RE: Amendment Application for Great Karoo Wind Energy Facility

This statement letter is in reference to the authorized Great Karoo Wind Farm (DEA REF 12/12/20/2370/3, as amended) and the request from Savannah Environmental (Pty) Ltd for comment on the ecological implications of the proposed changes to the layout and turbine specifications that would be included in the amendment application to the Department of Environmental Affairs.

Figure 1. Sensitivity map of the Great Karoo WEF site, depicting the amended layout of the facility as considered within this amendment, overlaid onto the original sensitivity map of the site as produced by Hoare (2014).

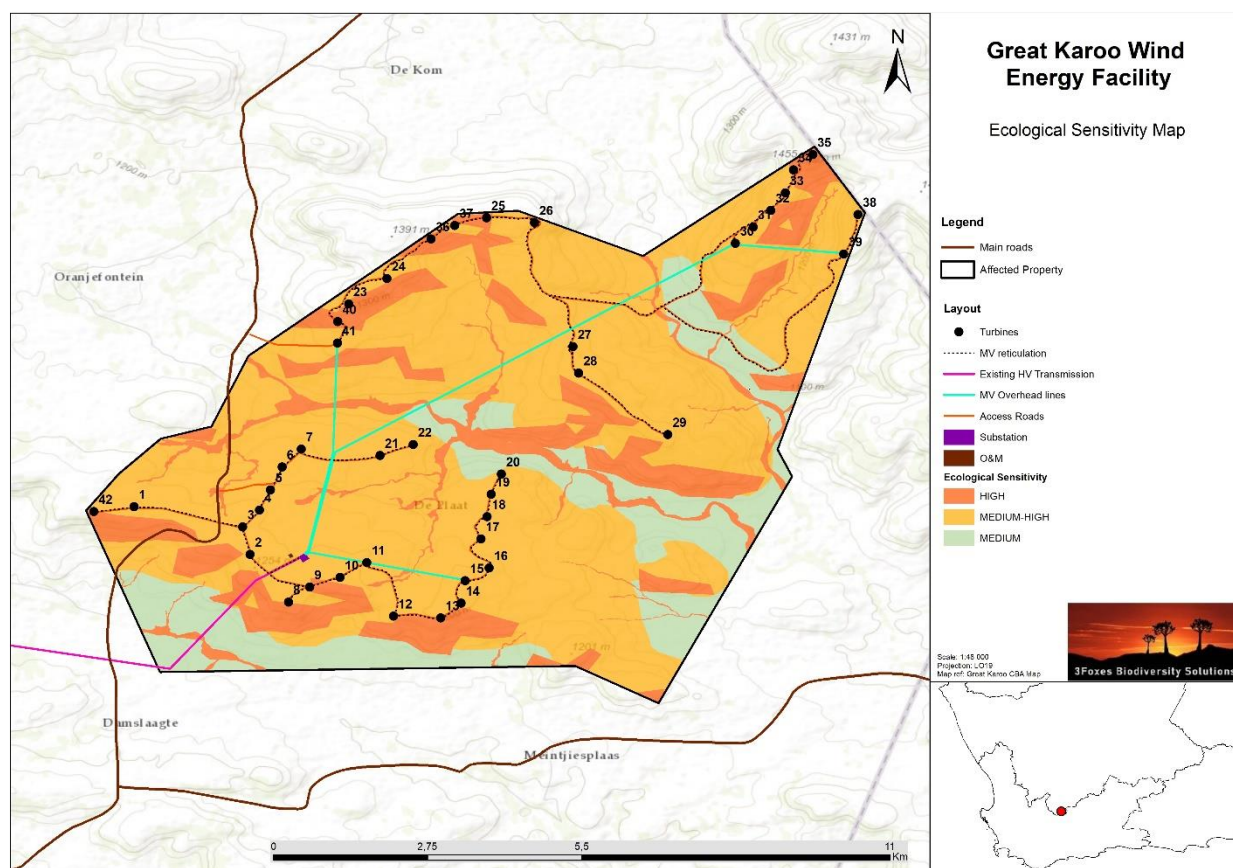
In terms of the original sensitivity map produced for the site, the ecological impact of the current proposed turbine layout would be similar or slightly lower than the most recent approved 52 turbine layout (Figure 1). The distribution of turbines, access roads and other infrastructure in relation to the assessed sensitivities of the site (Hoare, 2014) are similar and an increased impact on the high sensitivity parts of the site **is not likely**.

An aspect that requires some attention is the distribution of underground vs. overhead cabling at the site (see Figure 1). The current amendment allows for the extent of internal overhead lines to be increased significantly compared to the assessed layout which included a larger amount of buried cabling. While this is seen as having a positive impact on terrestrial ecology within the high sensitivity parts of the site, this is not the only consideration in this regard. An increase in overhead lines is likely to have some implications for avifauna and as such, the recommendations of the avifaunal specialist in this regard should take precedence within all areas except High ecological sensitivity areas, where specific input from an ecologist should be sought regarding the acceptability and routing of underground vs overhead MV lines. As such, the total extent of overhead lines on the site should be guided largely by avifaunal considerations, with ecological considerations only being of high importance in high and very high sensitivity parts of the site.

Figure 2. The current turbine layout in relation to the Namakwa District CBA which was used to inform the original ecological study

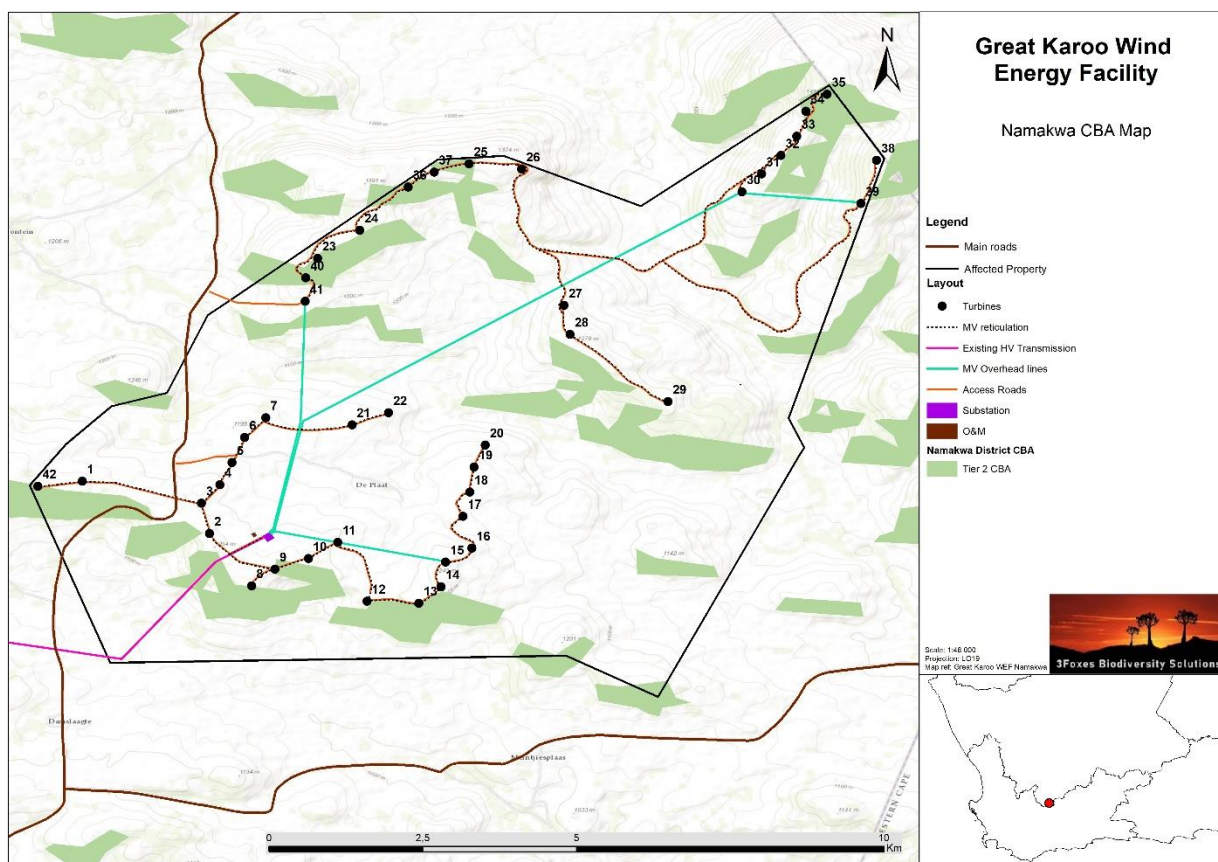
CBA database mapped south-facing slopes and kloofs as CBA 2 areas (Figure 2), but these are generic features that are not necessarily the high biodiversity or ecologically important parts of the site, especially in the Roggeveld, where lowlands and drainage features are often of higher sensitivity due to the higher abundance of species of concern in these areas.

Figure 3. The current turbine layout in relation to the more recent 2018 Northern Cape CBA map which has superseded the Namakwa District map.

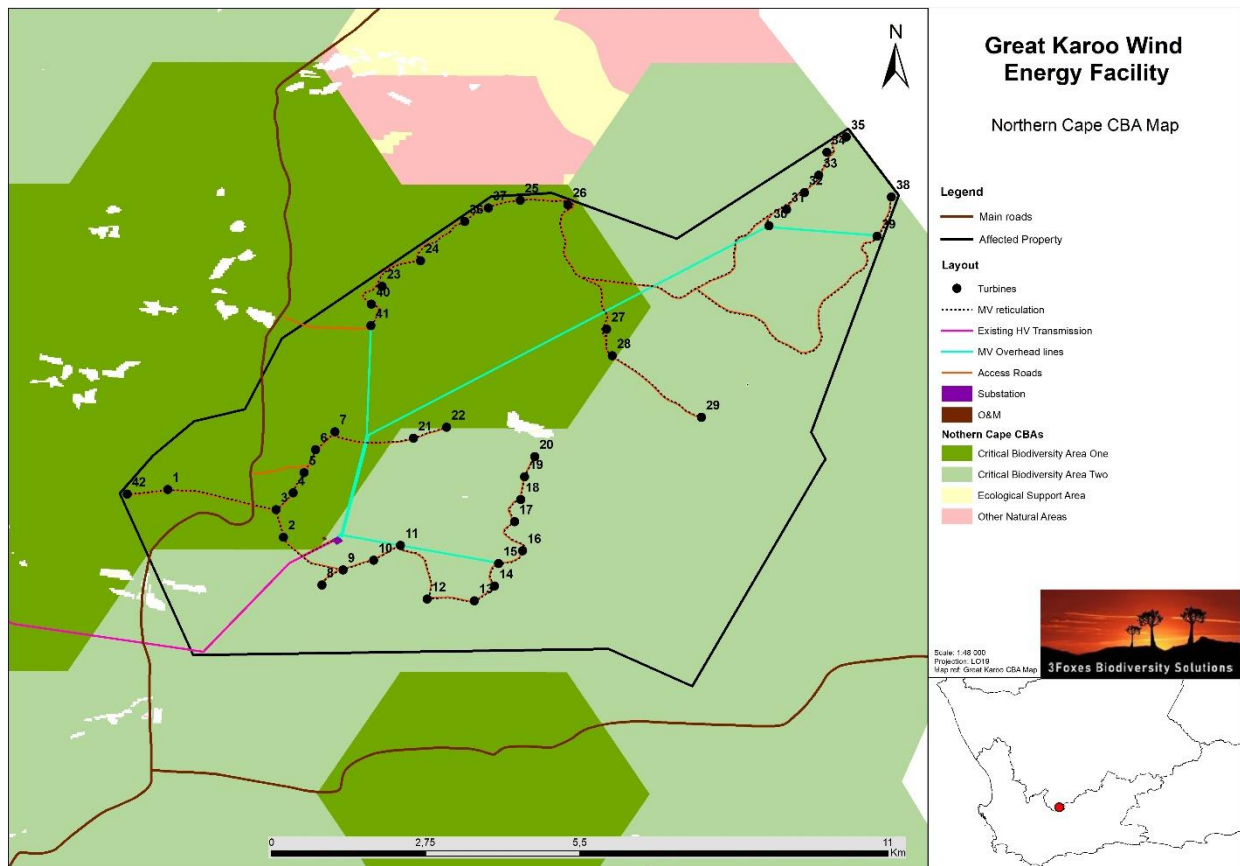
As the 2018 Northern Cape CBA map (Figure 3) does not indicate why an area has been selected as a CBA, it is not possible to tell why the areas within the site have been selected as CBAs, however, this appears to be related to the topographic diversity of the area as well as the fact that the area falls within the Roggeveld Centre of endemism, with a high abundance of plant species of concern. As the 2018 CBA map was not available at the time of the original assessment, it cannot be used to provide a comparison with the original assessment as it represents new information that has since become available.
